ADDENDUM NO. 2

Date: March 21, 2024

Project: West Regional Library Renovation
Cary, NC

POWER PLAN

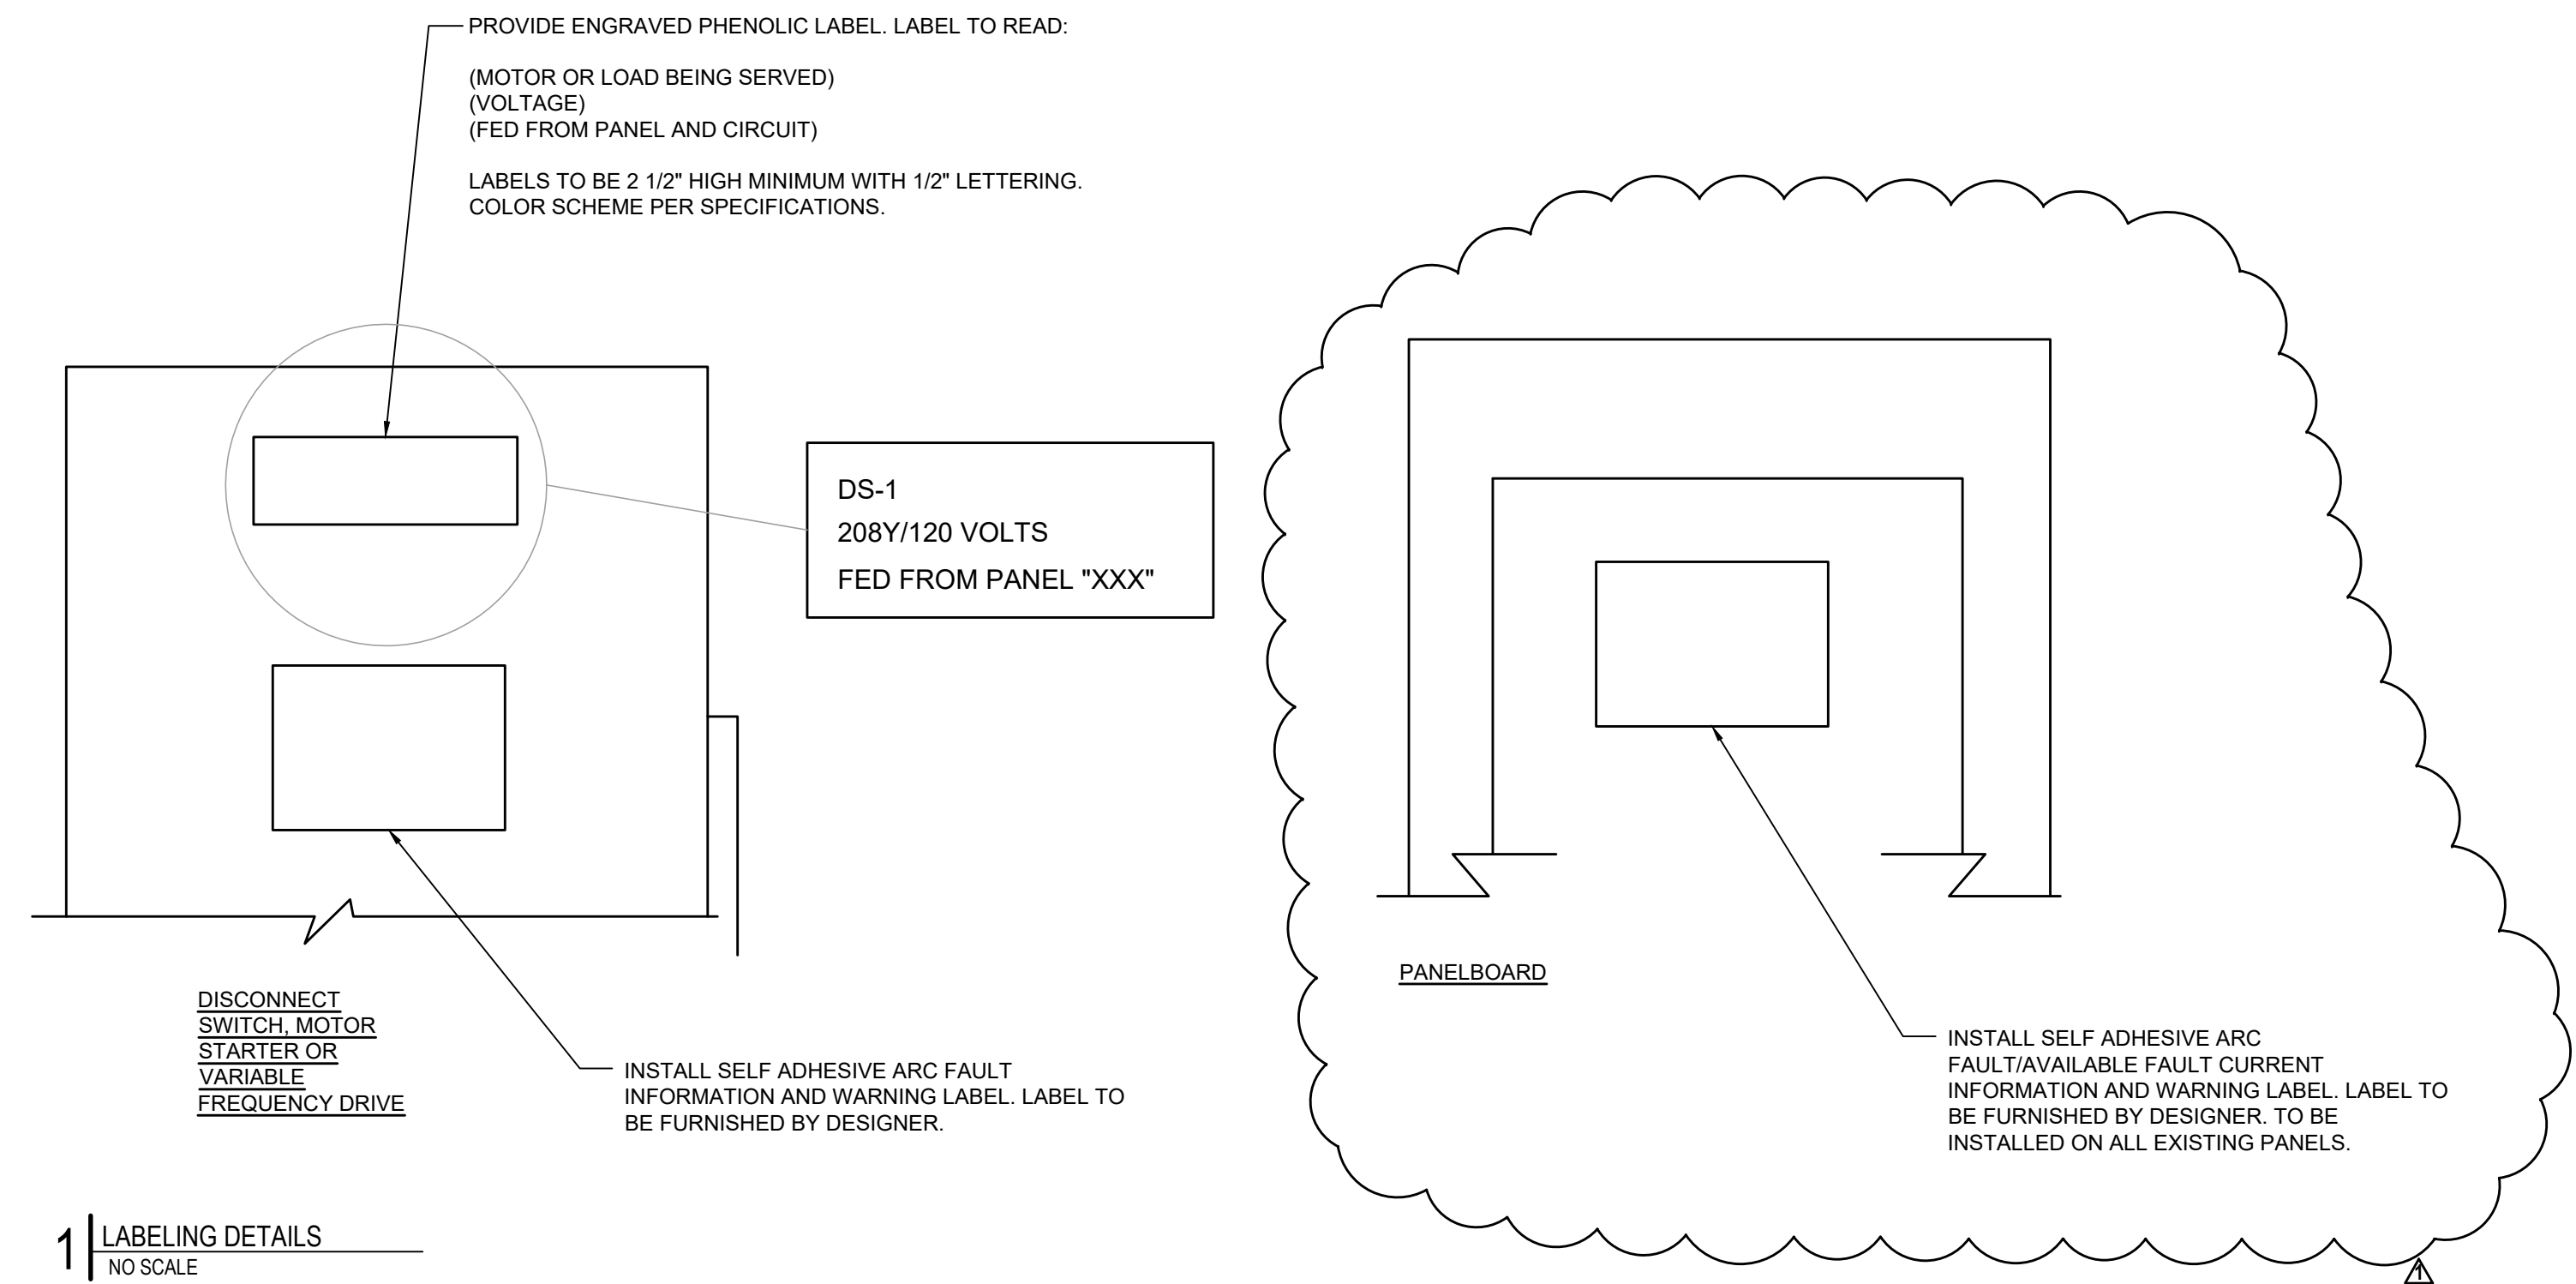
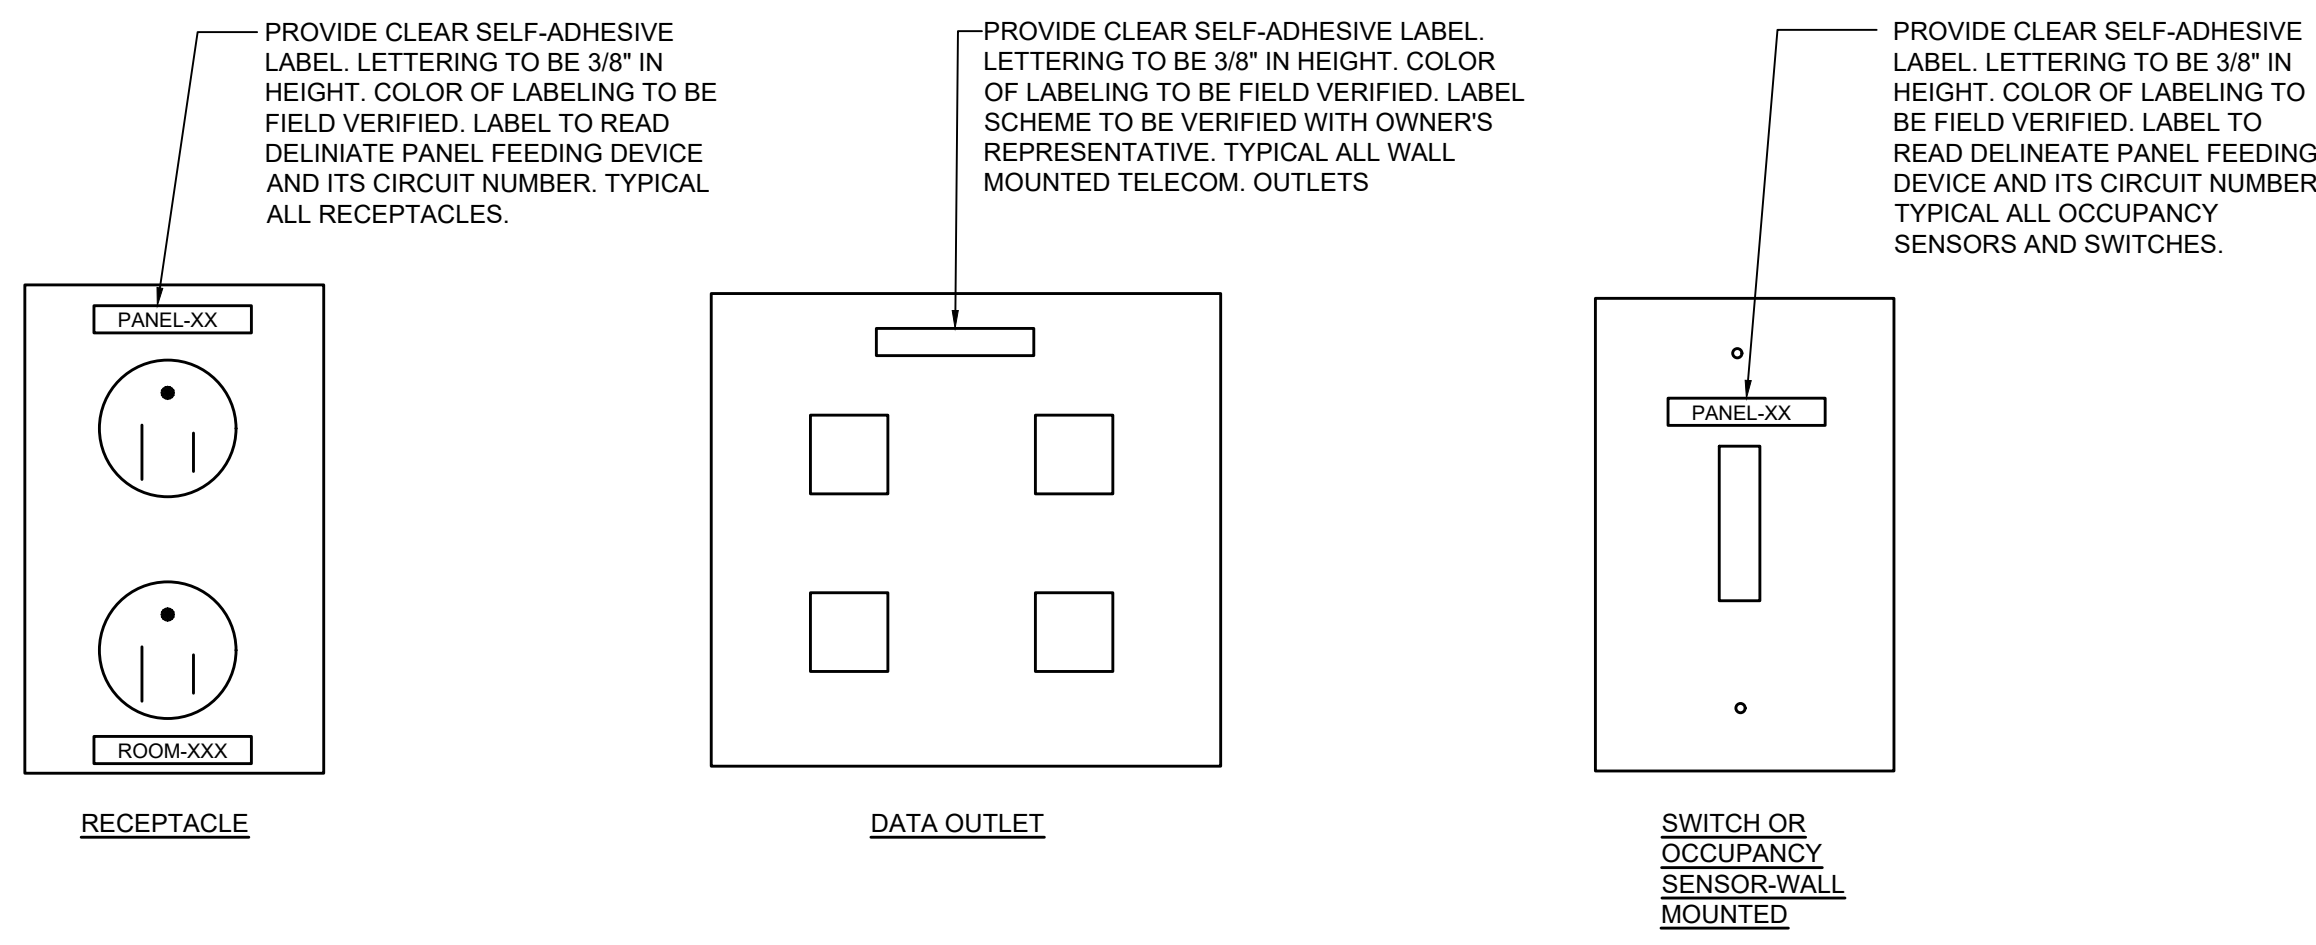
ITEM 19: Sheet E201-sheet has been **revised** to reflect changes related to the installation of exterior receptacles and installing raceway from exterior planting beds to interior of the building. Cutting and patching notes have been added to certain keynotes as well.

SHEET NO.
E500

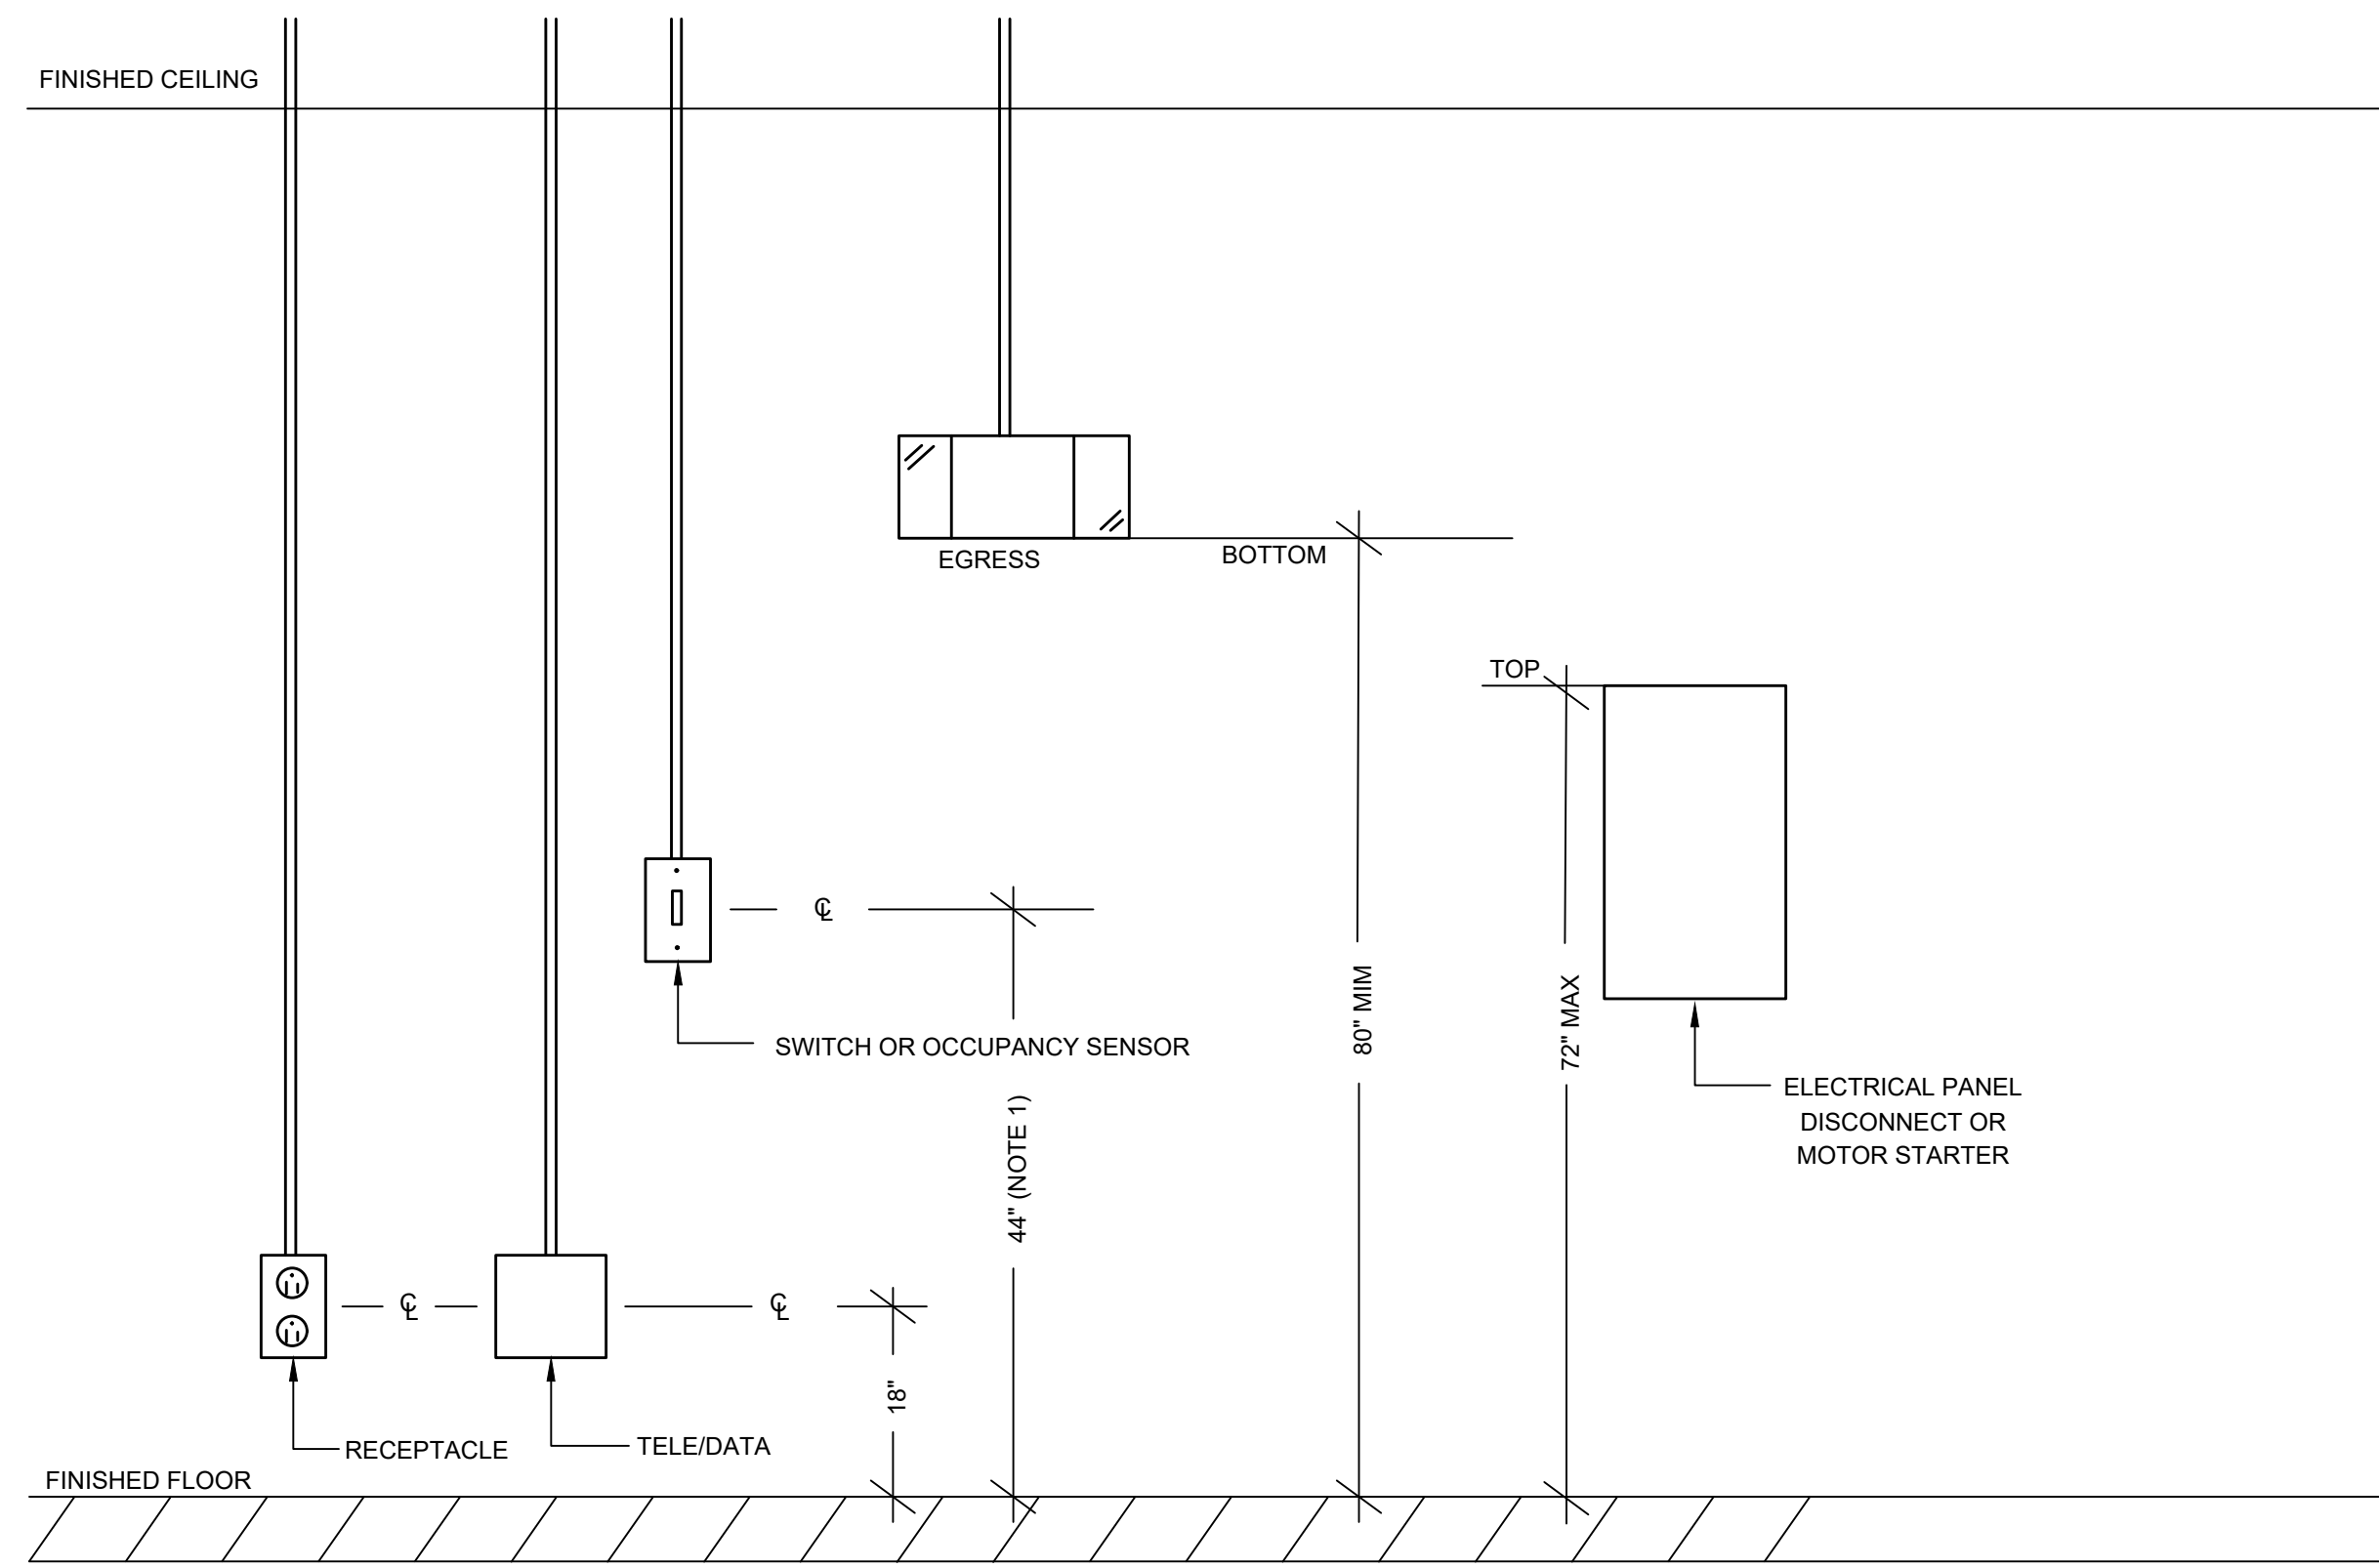
ITEM 20: Sheet E500-sheet has been **revised** to reflect labeling requirements at all existing panelboards as requested by Wake County Inspections.
